Access Compliance Report

Public Rights-of-Way

(Curb Ramps)

Intersection ID: 10033082	Main Street: NORTH_REA_PARK_LN	Cross Street: N/A	Location: N
ADA ID: F5BCD3D48DE7	Ramp Type: Perp	Initial Pass/Fail: Pass	Overall Compliance: No
Severity Score: 0.25			
Codes/Mitigation Info/Possible Solution		Field Measurements/Component Compliance

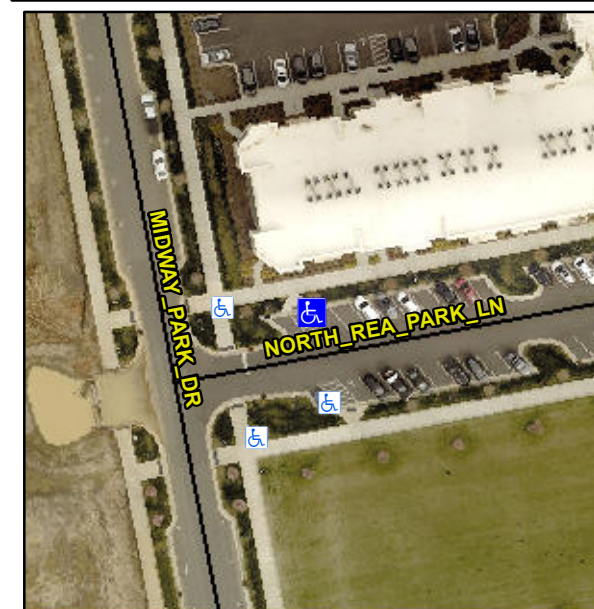
R304.5.3

Compliance	Description	Data	Compliance	Description	Data
N/A	Ramp Length (in)	95.0	Yes	Ramp Slope (%)	7.3
Yes	Ramp Width (in)	59.0	No	Ramp XSlope (%)	3.0
N/A	Flare Type LT	Sloped	N/A	Flare Type RT	N/A
N/A	Flare Slope LT (%)	6.6	Yes	Flare Slope RT (%)	8.9
N/A	Flare Traversable LT?	Yes	N/A	Flare Traversable RT?	Yes
Yes	Landing Length (in)	95.0	Yes	DWS Provided?	Yes
Yes	Landing Width (in)	60.5	Yes	DWS Contrast?	Yes
Yes	Landing Slope (%)	1.7	Yes	DWS Length (in)	24.0
Yes	Landing X Slope (%)	0.9	Yes	DWS Full Width?	Yes
N/A	Landing Curb? (Y/N)	No	Yes	DWS Offset (in)	0.0
N/A	Shared Landing?	No			
Yes	Gutter Ponding?	No	Yes	Gutter Slope (%)	4.4
Yes	Gutter Lip Ht (in)	0.0	Yes	Gutter X Slope (%)	1.2
N/A	Painted X Walk1?	No	N/A	Painted X Walk2?	N/A
	X Walk 1 Direction	To S		X Walk 2 Direction	N/A
N/A	X Walk 1 Width (in)	N/A	N/A	X Walk 2 Width (in)	N/A
	X Walk 1 Slope (%)	4.6		X Walk 2 Slope (%)	N/A
	X Walk 1 X Slope (%)	0.3		X Walk 2 X Slope (%)	N/A

Remove & Replace Entire Ramp.
